BUILDING INSPECTION DEPARTMENT

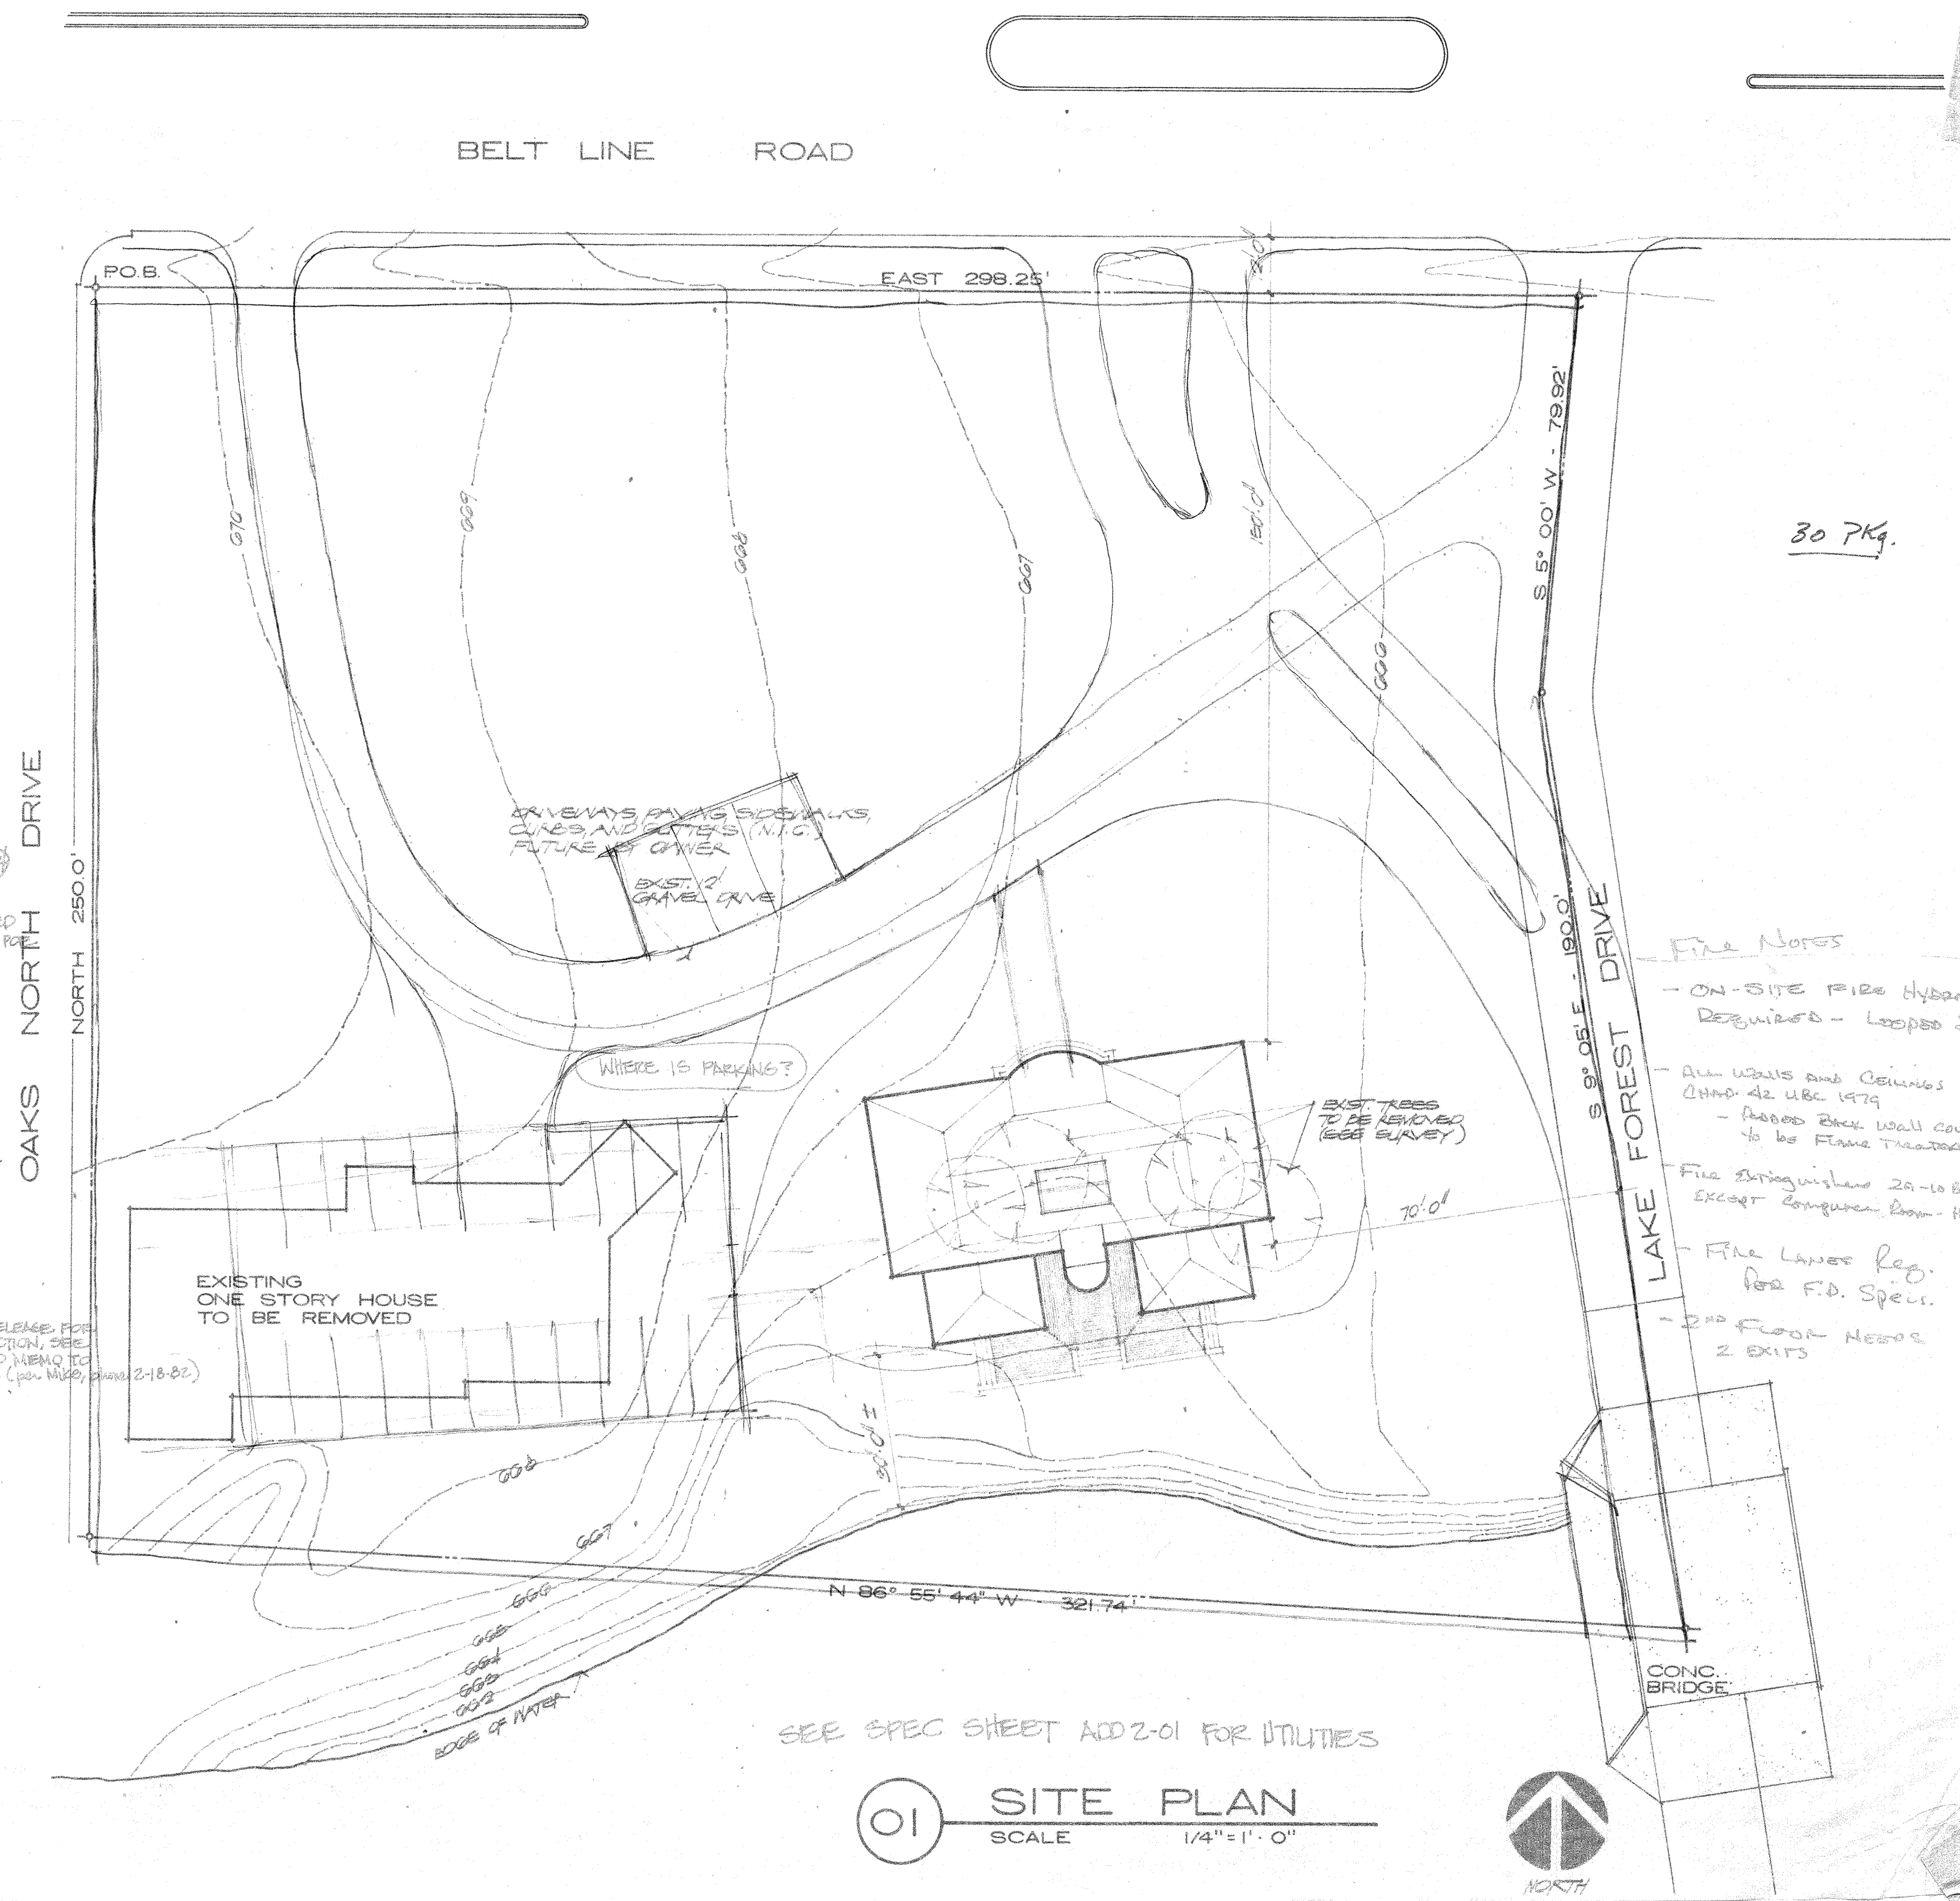
- NOTES :
1. NEED PARKING LAYOUT
 2. REVISE 2ND FLR TO SHOW CORRIDOR EXTENSION
 3. NEED STAIR DETAIL FOR 2ND FLR STAIR
 4. REVISE 1ST FLR TOILET AREA
 5. IF BLDG LOCATION IS CHANGED NEED REVISED SITE PLAN
 6. SEE NOTES ON ATTACHED SPECS
 7. SEE NOTES ON VARIOUS SHEETS
 8. INTERIOR FINISHES MUST COMPLY W/ CH. 42.0 BC
- TYPE I - N CONST / B-2 OCCUPANCY
 CITY OF ADDISON

- File Notes
- ON-SITE FIRE HYDRANT REQUIRED - LOOPS
 - ALL WALLS AND CEILING PER CHAP. 42.0 BC 1979
 - ASBESTOS BACK WALL COVER TO BE FIBER TREATING
 - Fire Sprinklers 20-10 BC EXCEPT CONCRETE ROOM - 1A
 - File Lower Reg. FOR F.D. SPEC.
 - 2ND FLOOR NEEDS 2 EXITS

HOLD FOR THESE ITEMS
